# 2015 Initial Annual Inspection Report

for Compliance with the Coal  
Combustion Residuals Rule  
(40 CFR Part 257)

## **Comanche Station**

**January 18, 2016**

**COMANCHE - COMMON**  
ASH LANDFILL  
DESIGN & OPERATIONS PLAN  
EXISTING CONDITIONS

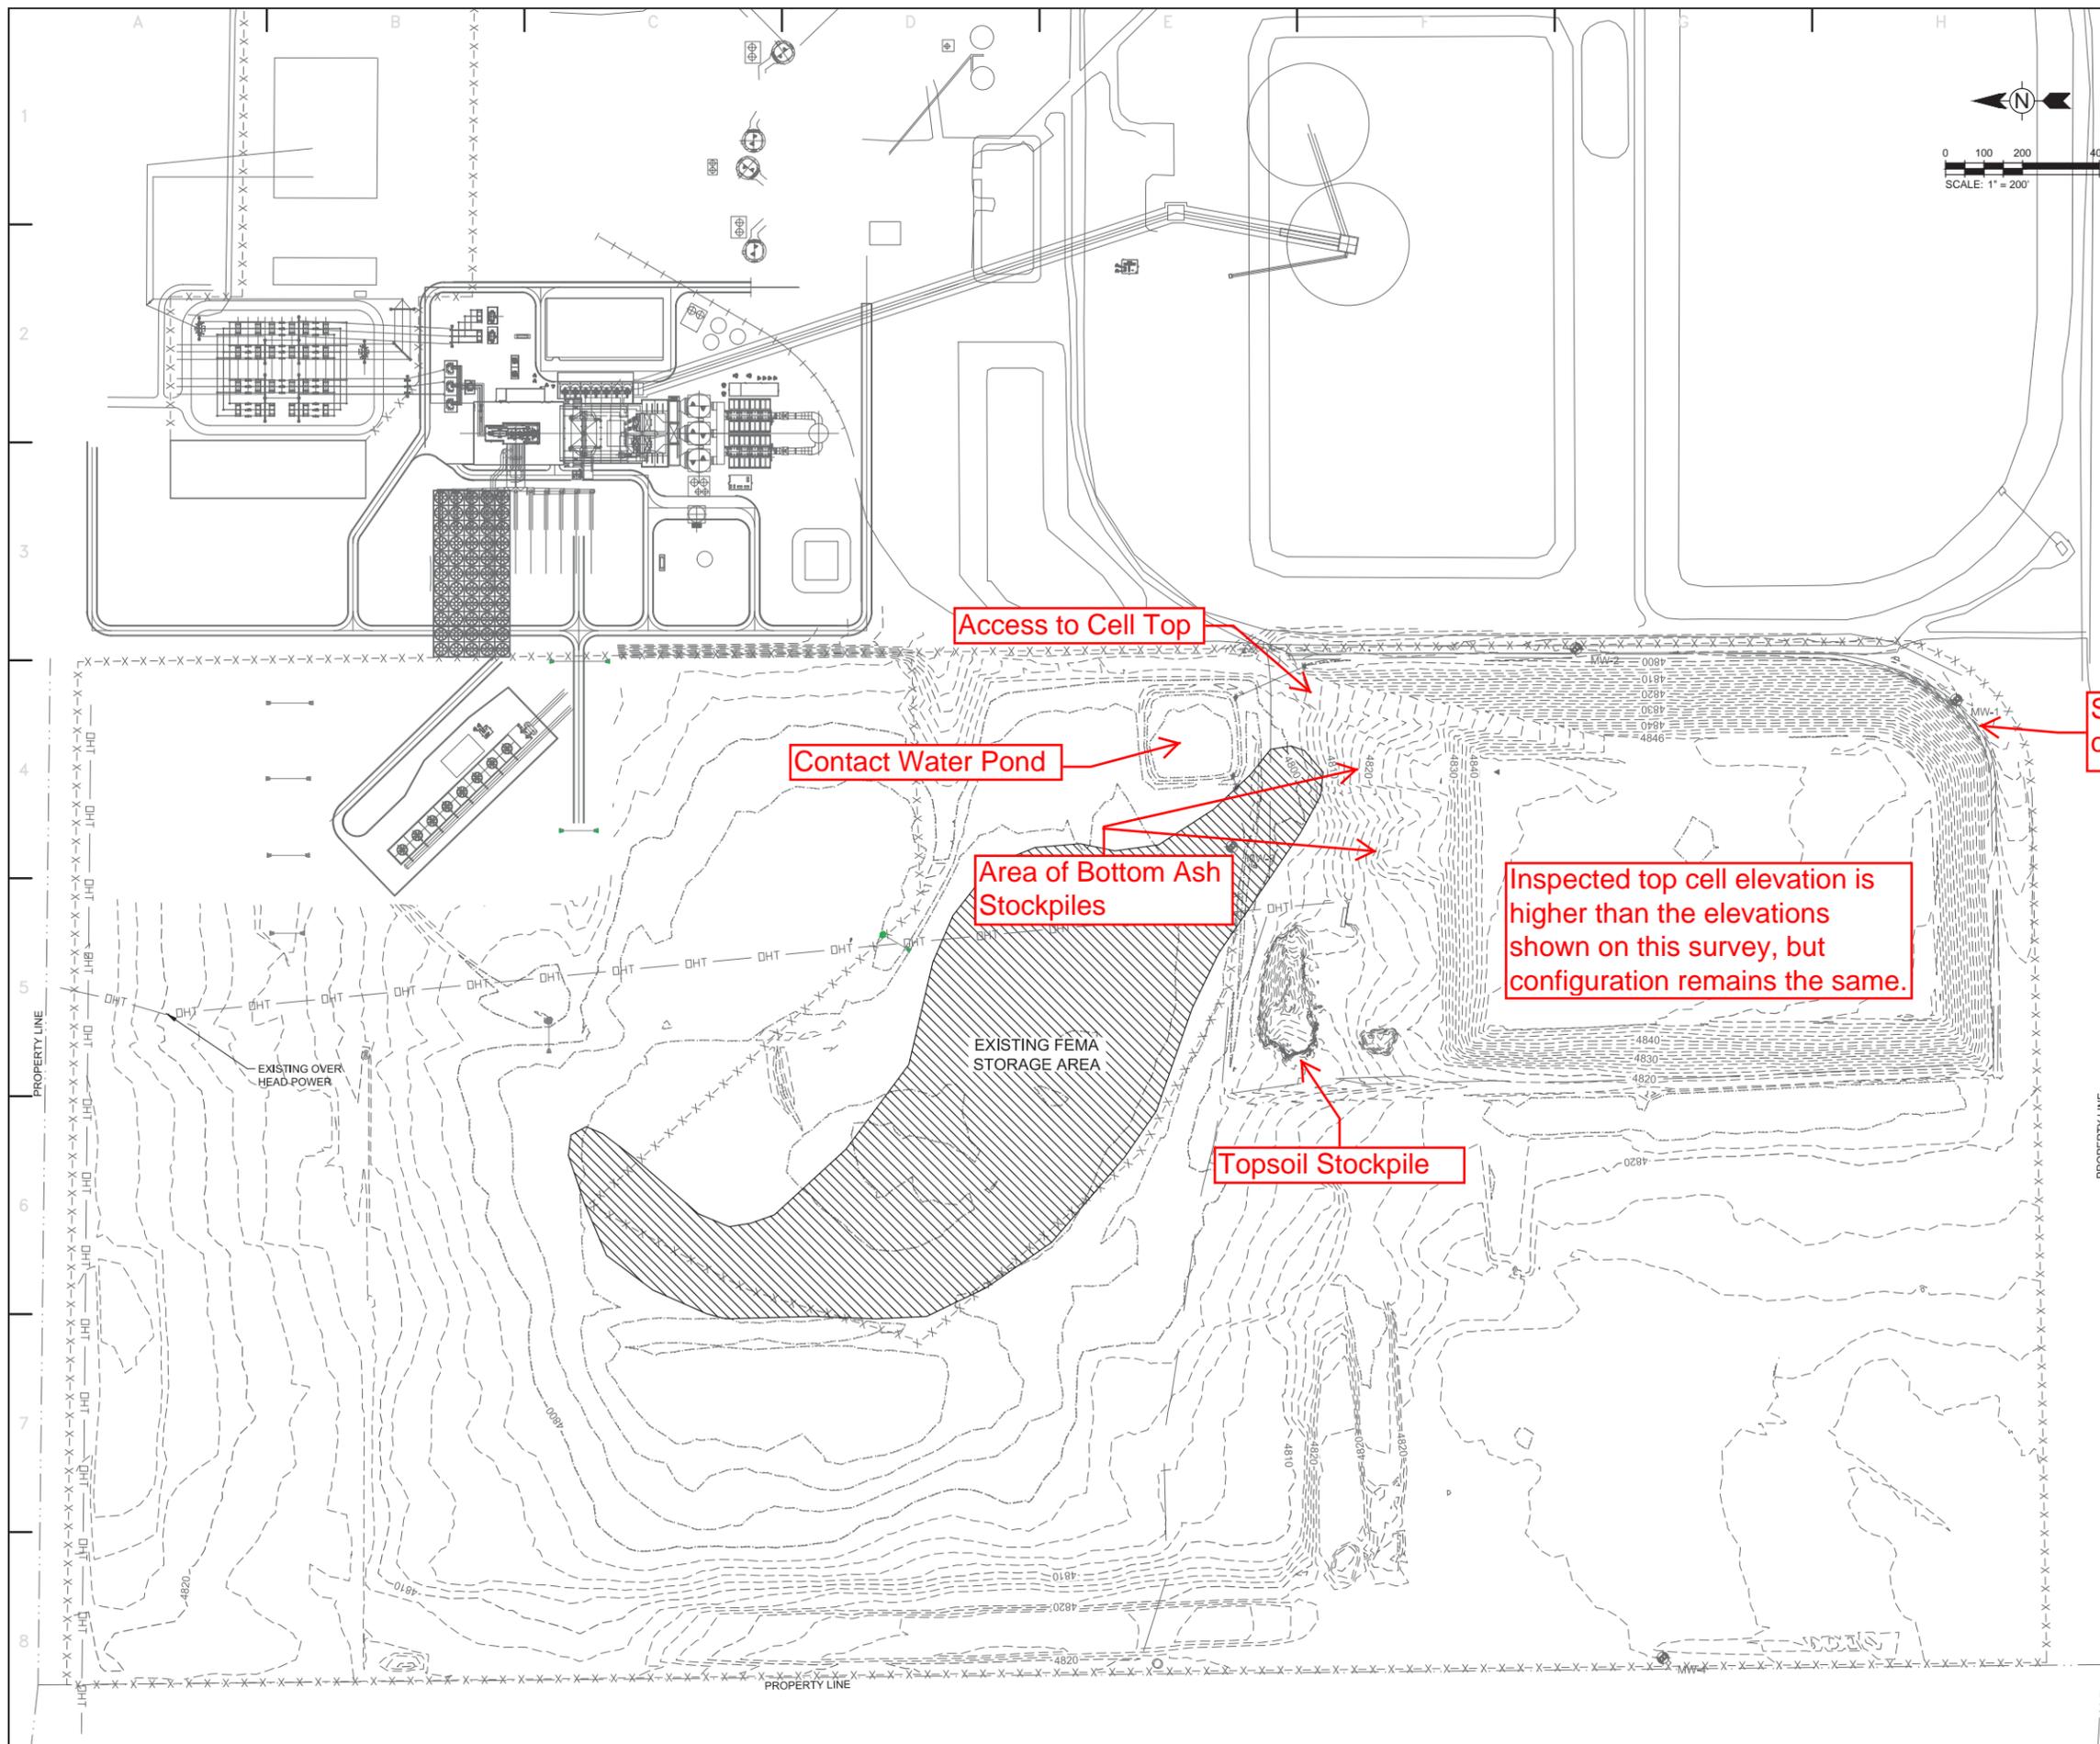
Access to Cell Top

Contact Water Pond

Area of Bottom Ash Stockpiles

Topsoil Stockpile

Inspected top cell elevation is higher than the elevations shown on this survey, but configuration remains the same.

SE Embankment corner with Cut Toe

Notes in red added by HDR Engineering for CCR Annual Inspection Report, January 2016
